Madison PUD / CUP

Windsong entry

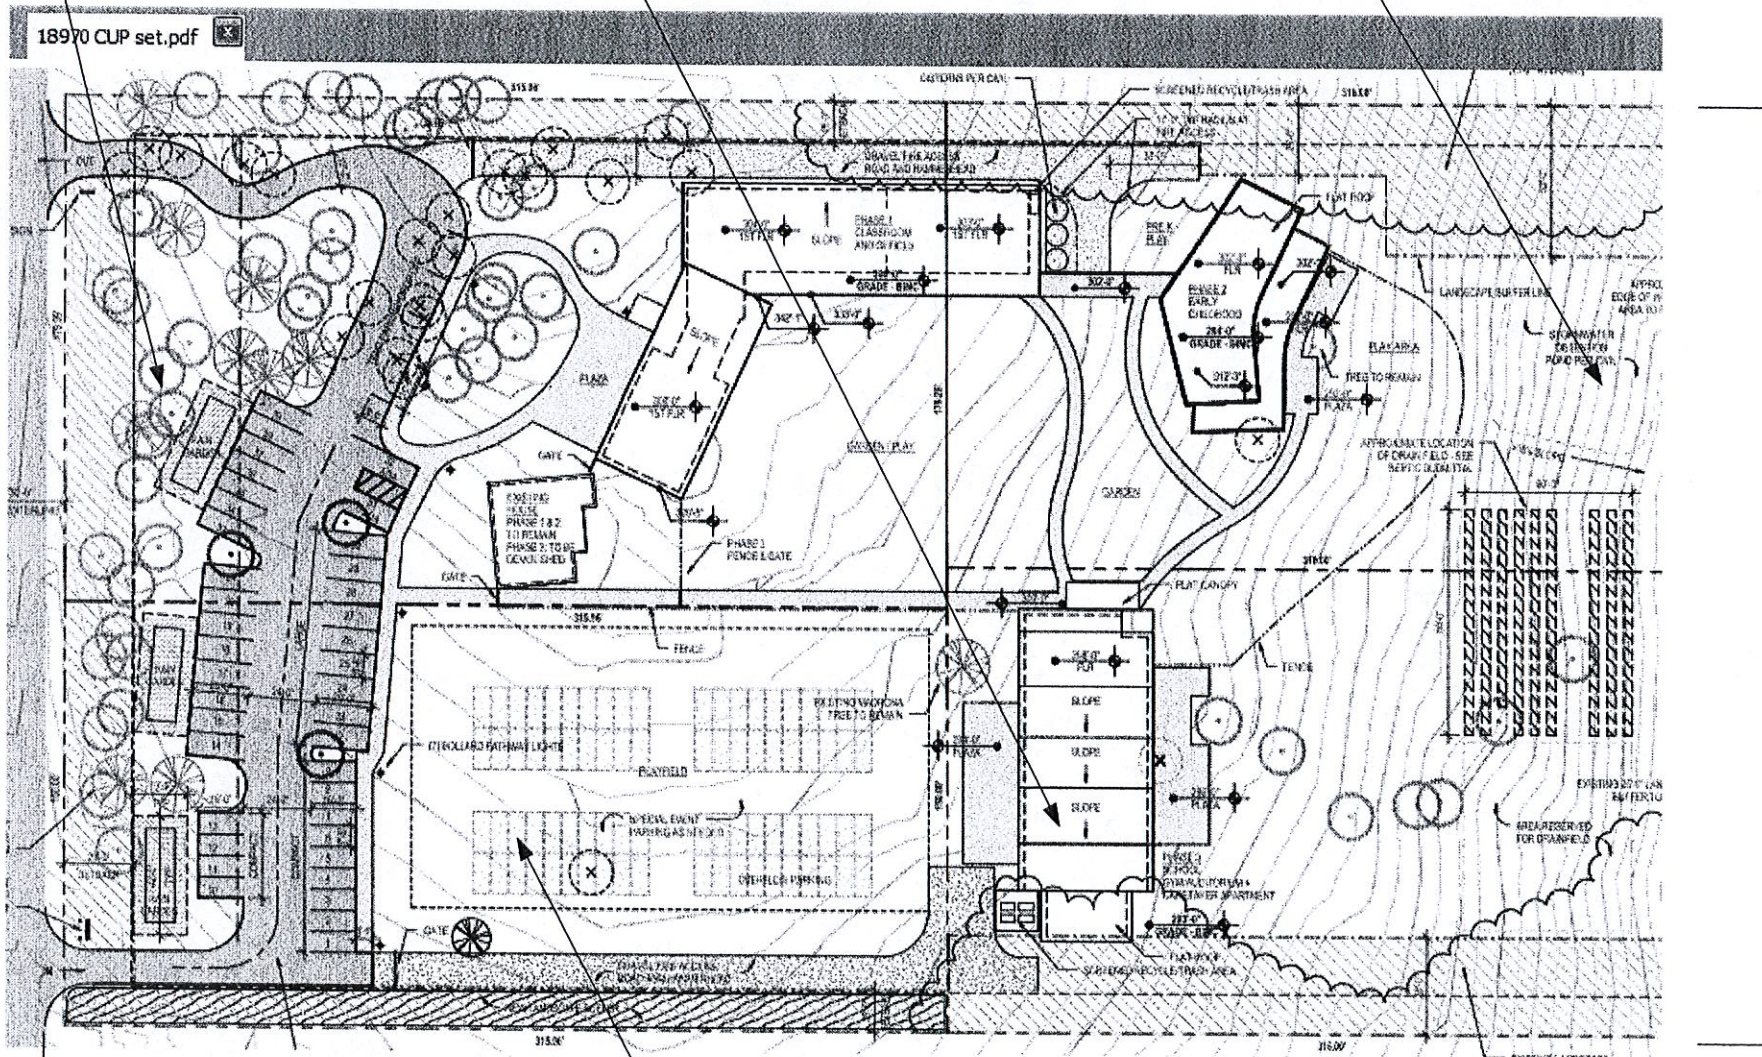
OF COURSE THEY CAN COME IN FROM NORTH AND SOUTH
BUT THAT DOES NOT REDUCE THE FACTS OF THE IMPACT
ON THE NEIGHBORHOOD

existing tree buffer is thin

gym 400 seating proposed !!
commercial use is not allowed

retention area too small
for eventual paved parking

80 "overflow" parking + 43 shown = 123 cars !!
you cannot expect our sub-urban neighborhood
to accept this "festival" parking load
